6/12/78	Revised 6th and 7th line of Legend
DATE	REVISION
STATE OF HAWAII DEPARTMENT OF TRANSPORTATION HIGHWAYS DIVISION	
KEEHI INTERCHANGE ELECTRICAL PLAN - PART I	
INTERSTATE ROUTE H-1 PROJECT NO. I-HI-1(130):17	
SCALE: NONE	DATE: AUG. 16, 1976
SHEET No. E1 OF E12 SHEETS

8/3/77	RELOCATED COLUMN MOUNTED LUMINAIRE FOR AT GRADE ROADWAY FROM RAMP II TO RAMP I
DATE	REVISION
STATE OF HAWAII DEPARTMENT OF TRANSPORTATION HIGHWAYS DIVISION	
KEEHI INTERCHANGE ELECTRICAL PLAN - PART II STAGE II CONSTRUCTION	
INTERSTATE ROUTE H-1 PROJECT NO. I-HI-1 (130):17	
SCALE: N.T.S.	DATE: AUG. 16, 1976
SHEET NO. 52 OF 52 SHEETS

8/3/77	RELOCATED UNDERGROUND RACEWAY AND RUN-UP AT COLUMN FROM RAMP II TO RAMP I
DATE	REVISION
STATE OF HAWAII DEPARTMENT OF TRANSPORTATION HIGHWAYS DIVISION	
KEEHI INTERCHANGE ELECTRICAL PLAN - PART III STAGE II CONSTRUCTION	
INTERSTATE ROUTE H-1 PROJECT NO. I-HI-1(130):17	
SCALE: 1" = 50'	DATE: AUG. 16, 1976
SHEET No. E3 OF 12 SHEETS

DATA BASED ON 250-WATT HPS 25,500 LUMEN LAMP @ 25' MTG.
PROVIDE LAMP DESIGNATION LU250/BD.

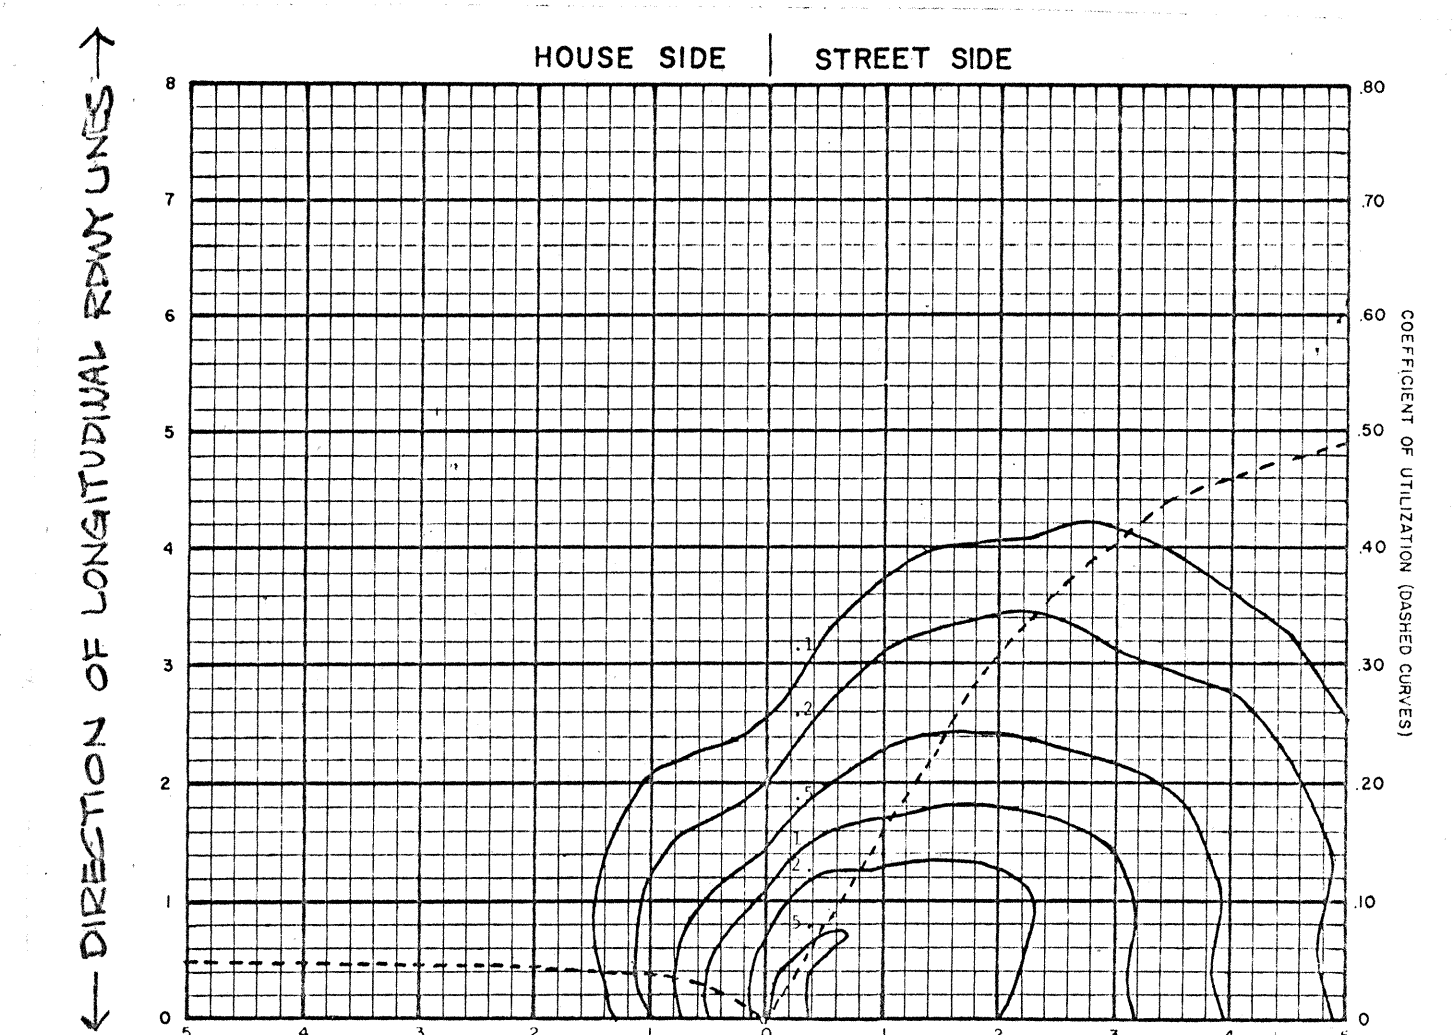
6/12/78	Revised Details 3/E5 and 6/E5
10/20/76	Removed Note 1. Revised dimensions of luminaires.
DATE	REVISION
STATE OF HAWAII DEPARTMENT OF TRANSPORTATION HIGHWAYS DIVISION KEEHI INTERCHANGE ELECTRICAL PLAN - PART V INTERSTATE ROUTE H-1 PROJECT NO. I-HI-1(130):17 SCALE: NONE DATE: AUG.16,1976 SHEET No. E5 OF 12 SHEETS

DETAIL 2/EG
FEEDER DIAGRAM

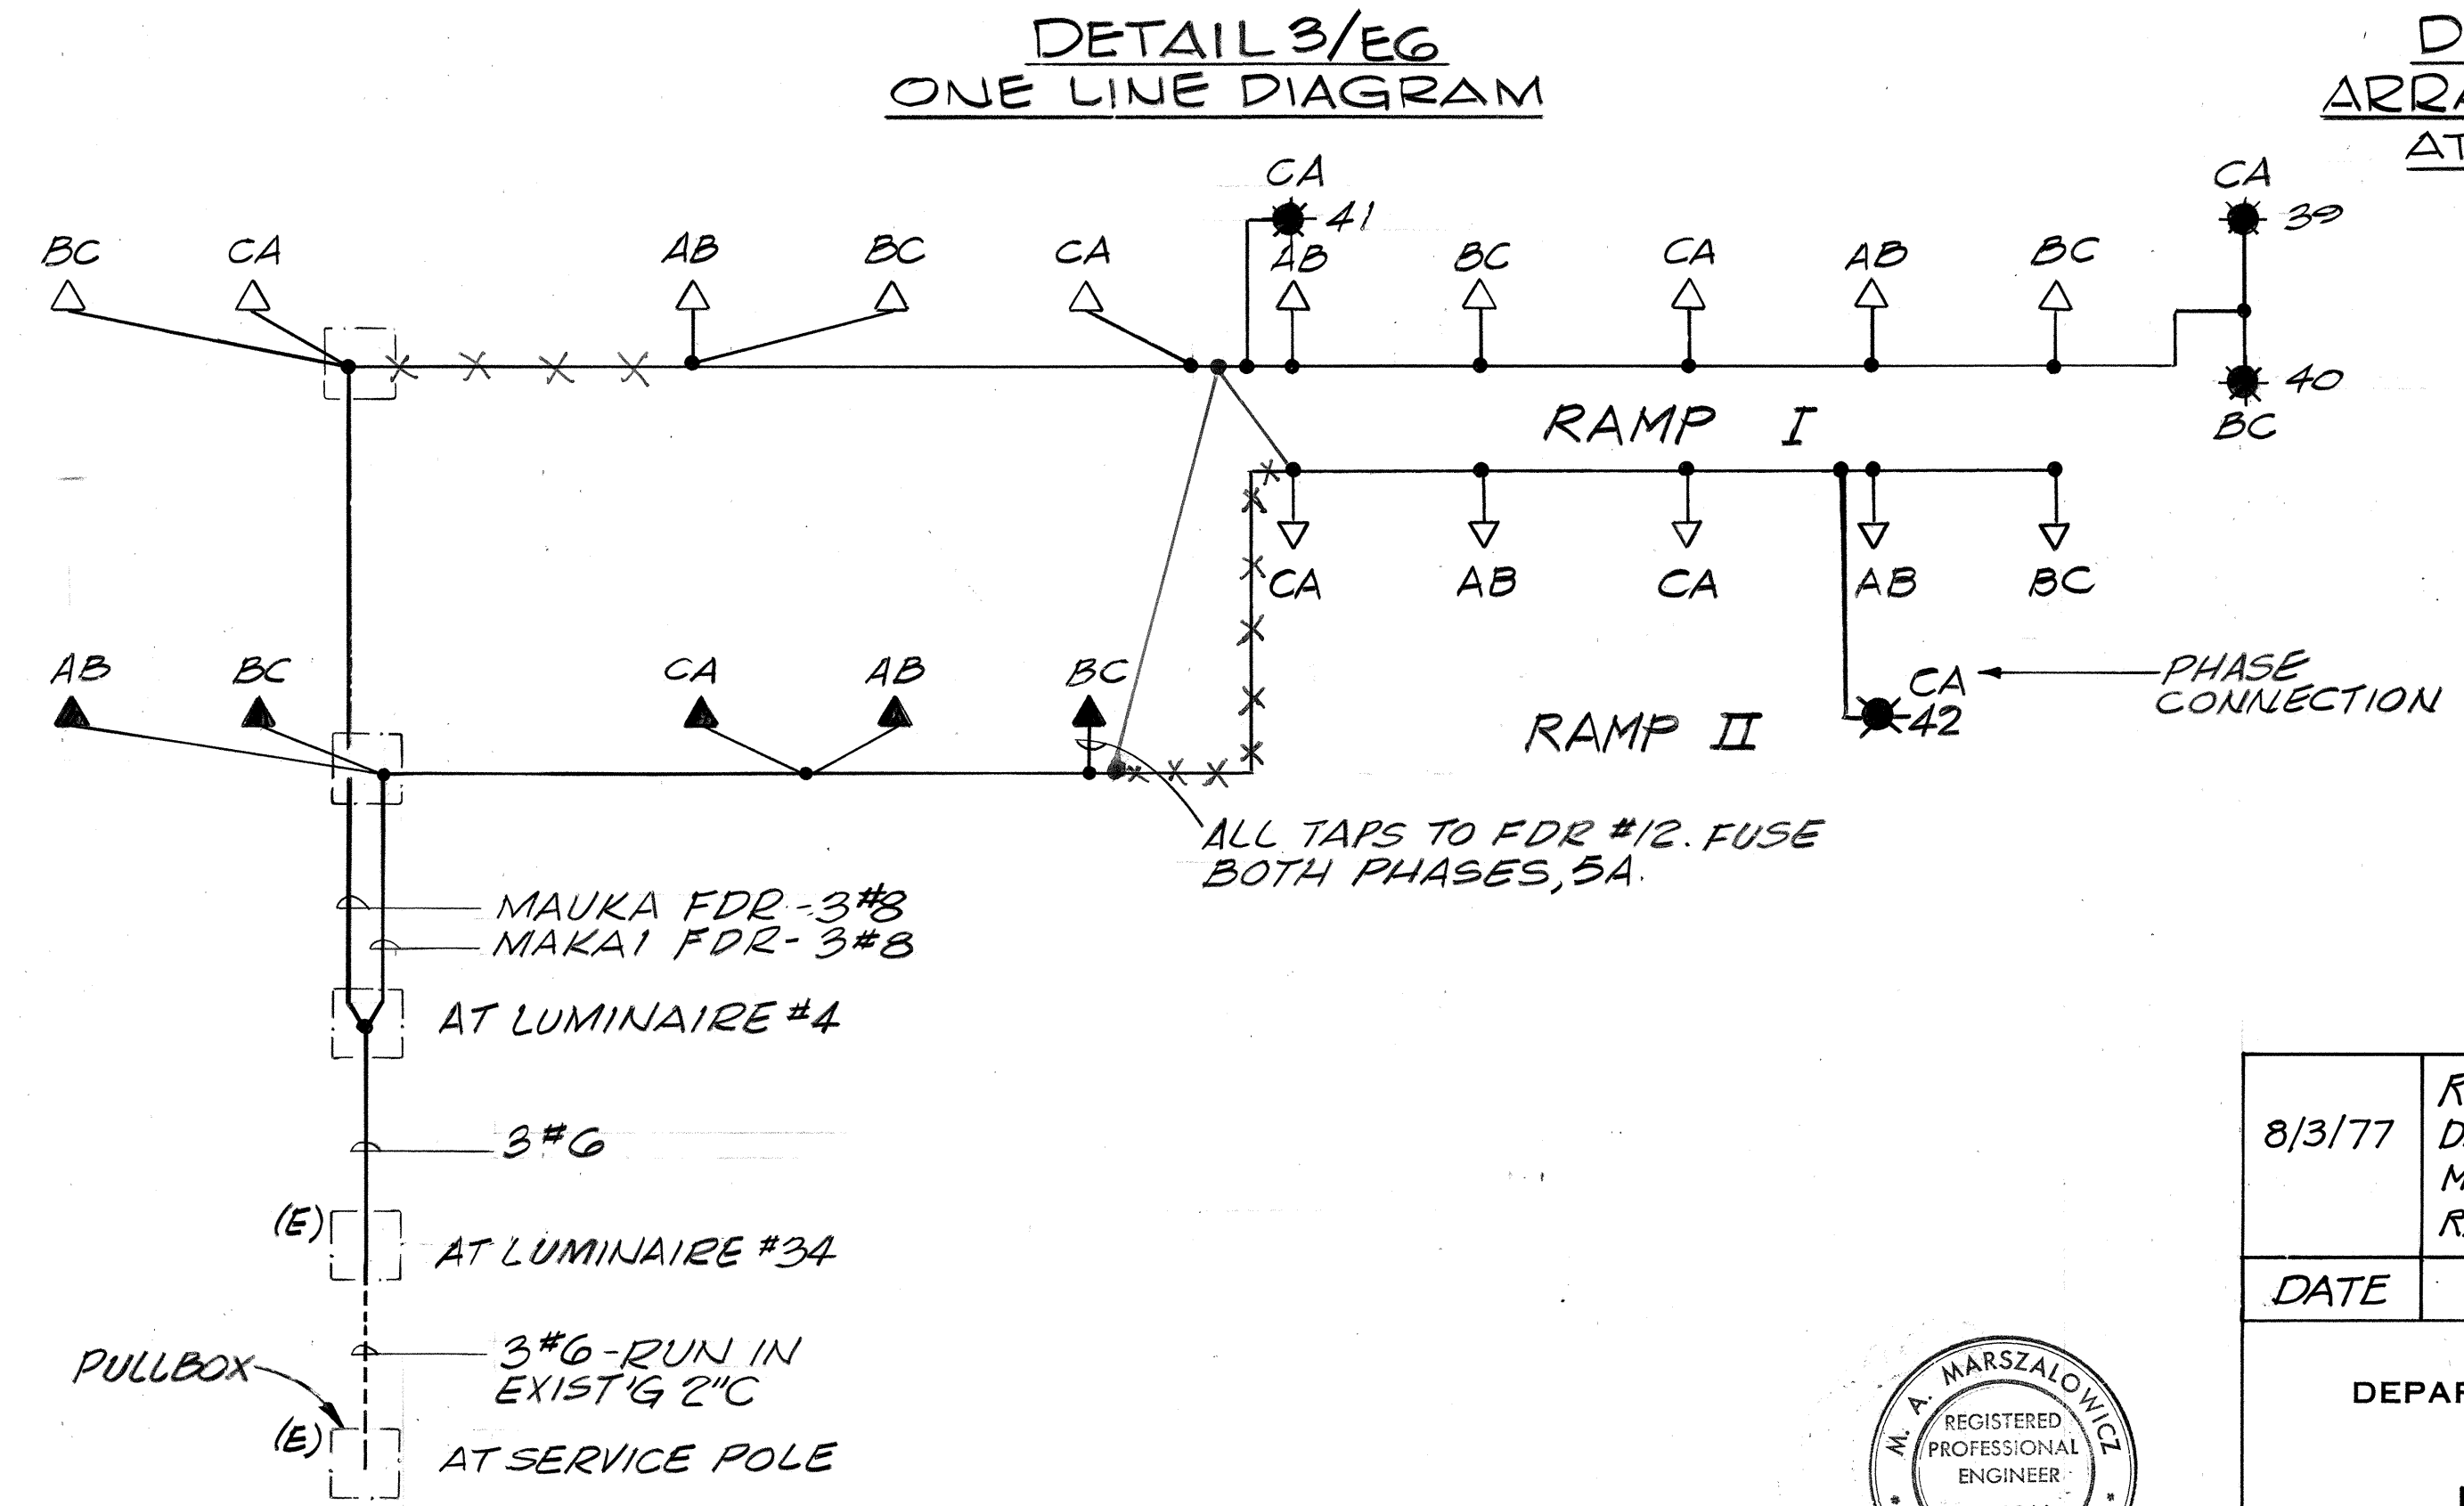
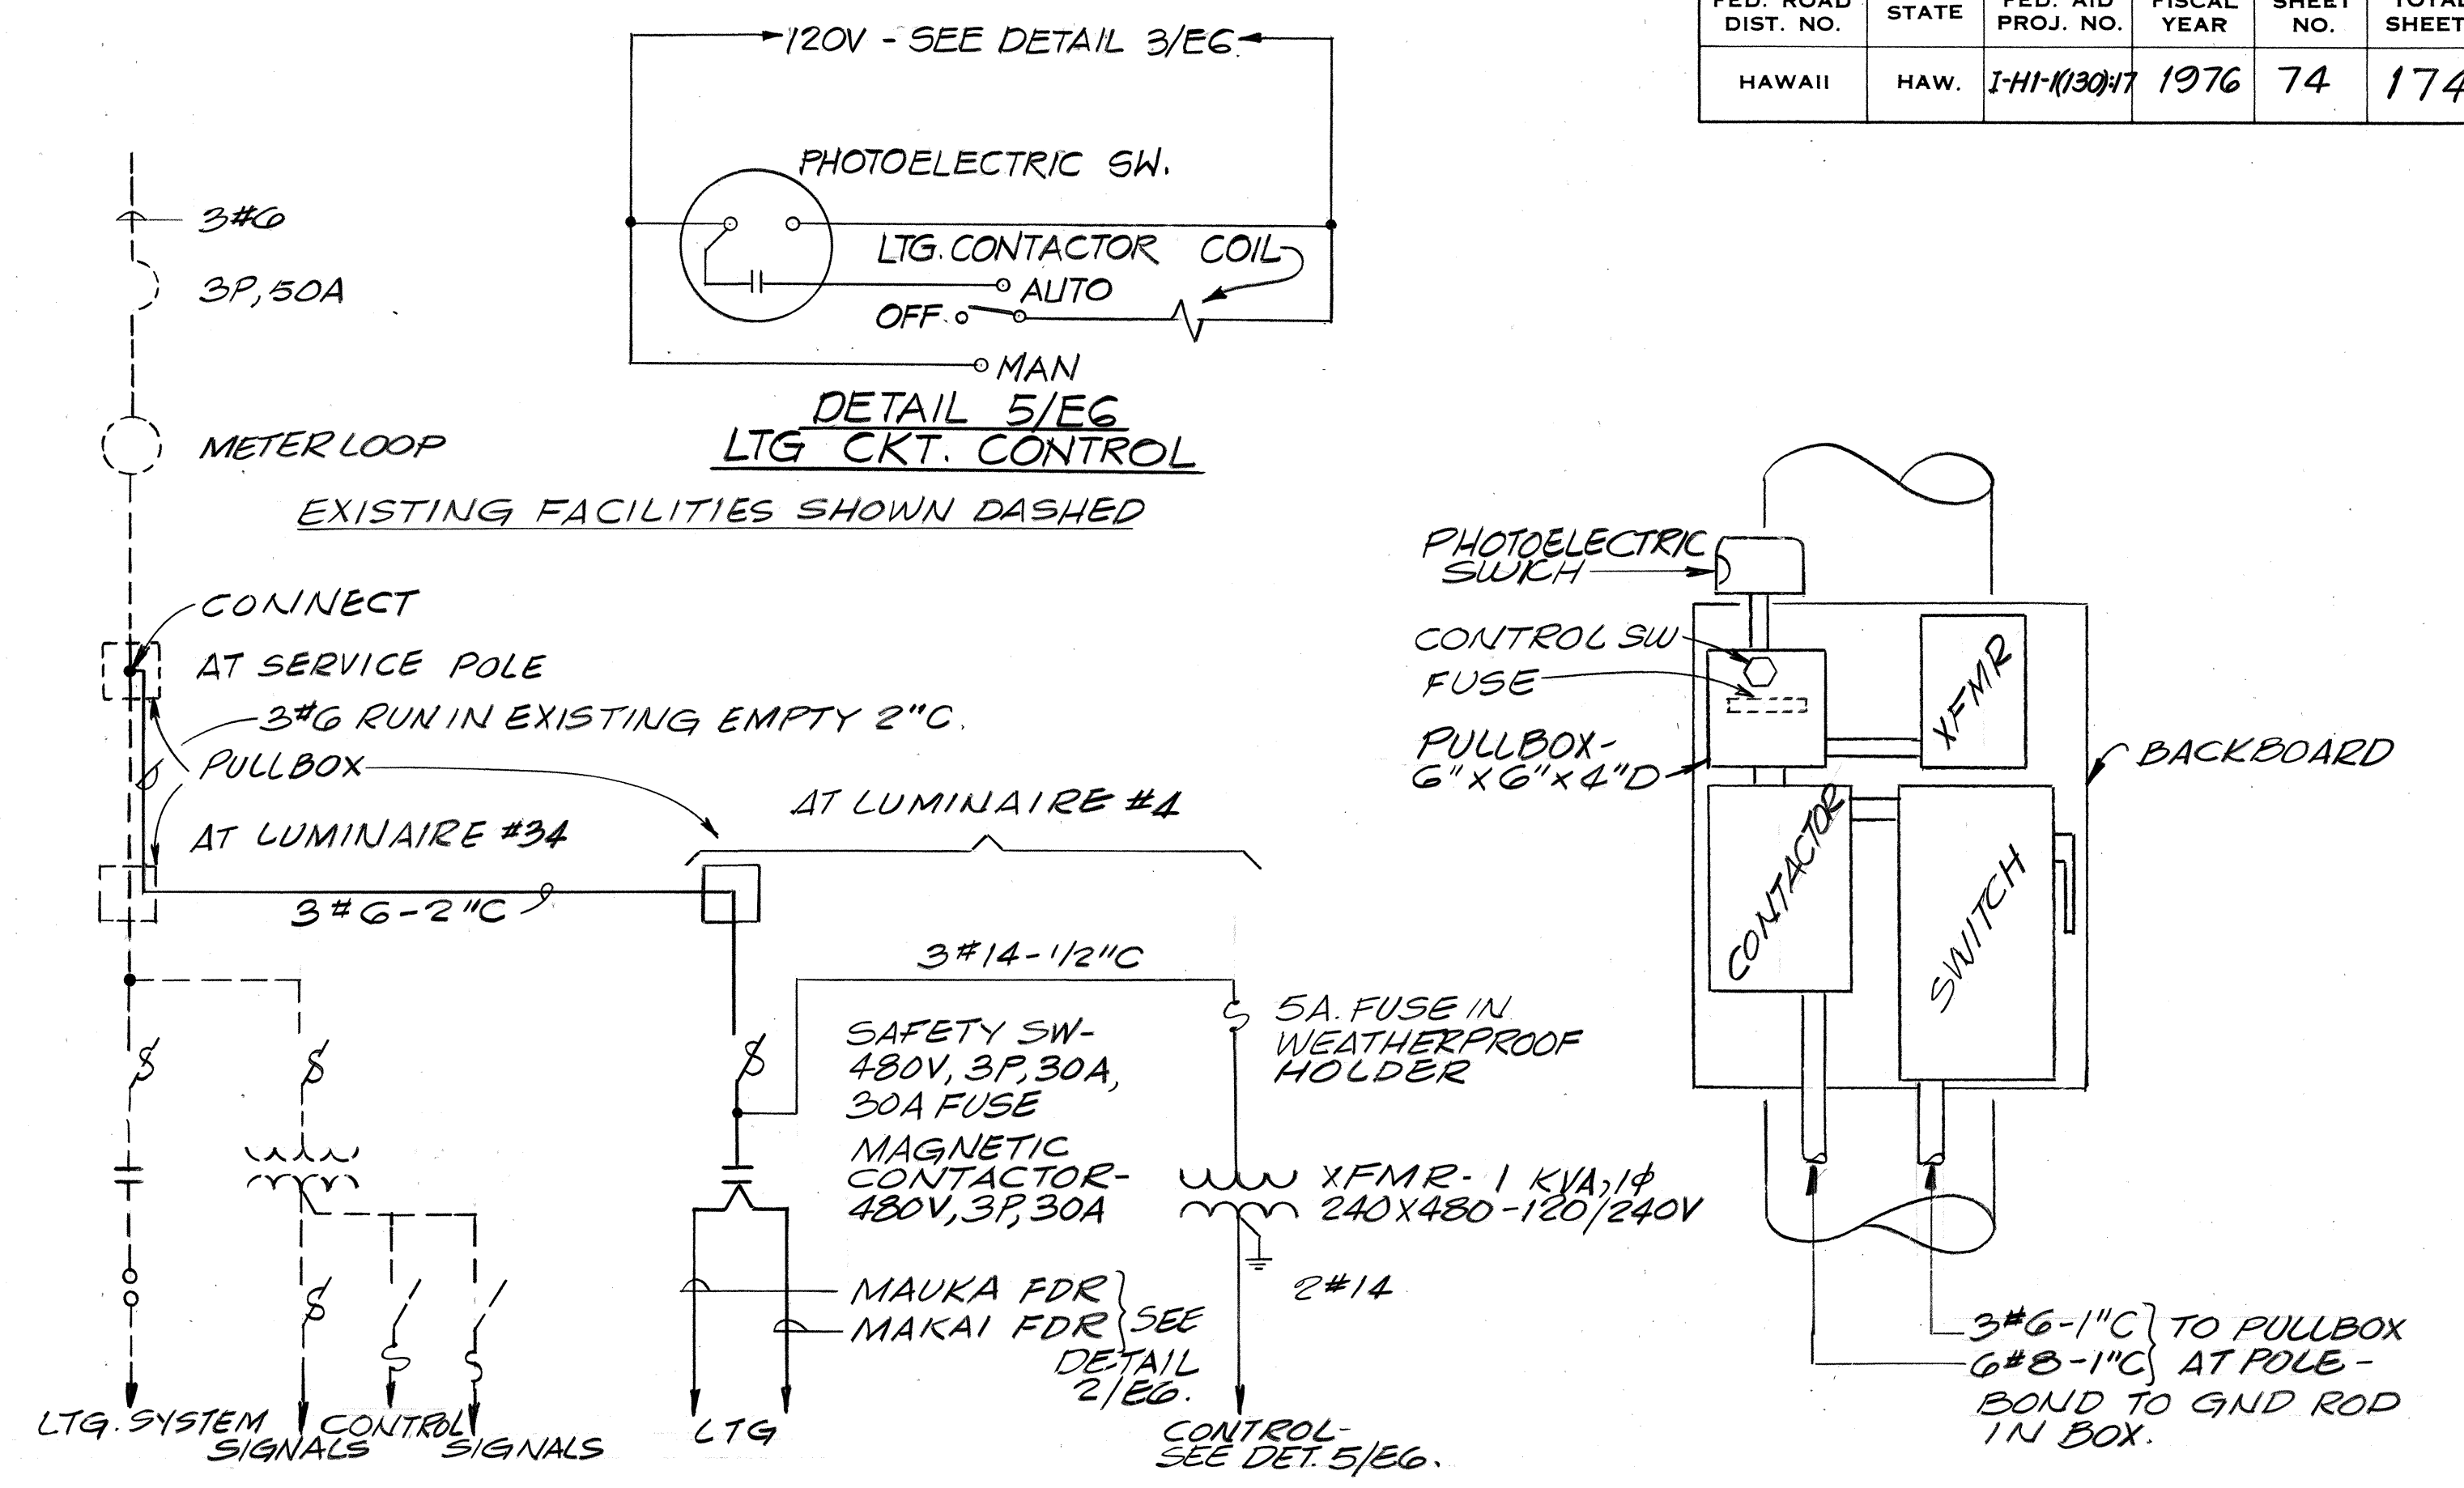
8/3/77	REVISED DETAIL 2/EG, FEEDER DIAGRAM, BY RELOCATING COLUMN MOUNTED LUMINAIRES FROM RAMP II TO RAMP I
DATE	REVISION
STATE OF HAWAII DEPARTMENT OF TRANSPORTATION HIGHWAYS DIVISION	
KEEHI INTERCHANGE ELECTRICAL PLAN - PART VI	
INTERSTATE ROUTE H-1 PROJECT NO. I-HI-1 (130):17	
SCALE: NONE	DATE: AUG. 16, 1976
SHEET NO. EG OF E/2 SHEETS

Change Order #22
